AIRPORT LAND USE COMMISSION RIVERSIDE COUNTY AGENDA

Thursday 9:00 A.M., April 12, 2018

- 2.1 ZAP1079FV18 – W. Development Partners of Temecula (Representative: Michael Schweitzer, SWS Engineering) - County Planning Case Nos. CUP03777 (Conditional Use Permit) and PM 37399 (Tentative Parcel Map). The applicant proposes to develop fifteen commercial buildings with a combined gross floor area of 144,315 square feet on 14.19 acres located on the northerly side of Benton Road, easterly of its intersections with Winchester Road and Penfield Lane, and westerly of a northerly straight line extension of Leon Road. The applicant envisions 7 office/warehouse buildings and 8 retail buildings (4 of which may include restaurants). Tentative Parcel Map No. 37399 would divide the project site into 15 lots ranging from 0.35 to 2.21 acres in size, providing individual lots for most of the proposed buildings. (Airport Compatibility Zones C, B1, and D of the French Valley Airport Influence Area). Staff Planner: John Guerin at (951) 955-0982, or e-mail at jguerin@rivco.org

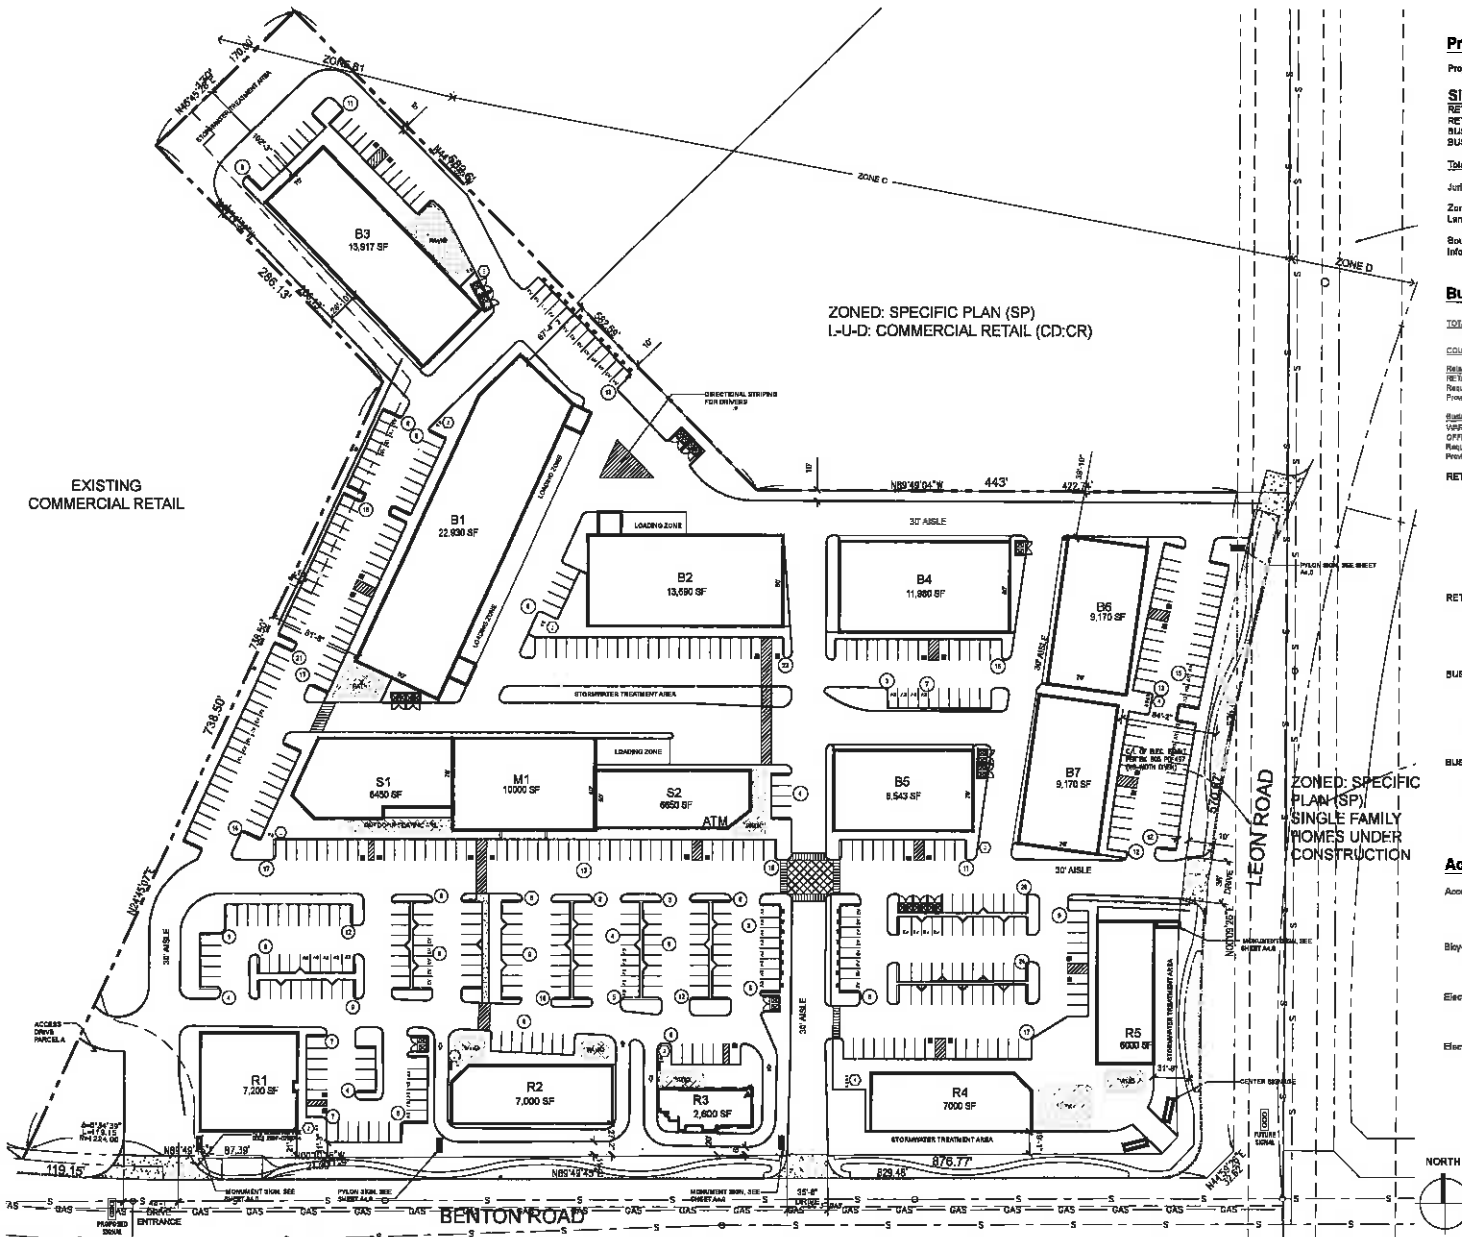
FYI – Spreadsheet lists Buildings M1 and S1 as Category 3 buildings. Category 3 is office/warehouse. However, the occupancy level is calculated using the non-food retail 1 person per 170 standard.

Business park numbers on site plan (office square footage) do not necessarily correspond to the 15/85 split referenced in the spreadsheet.
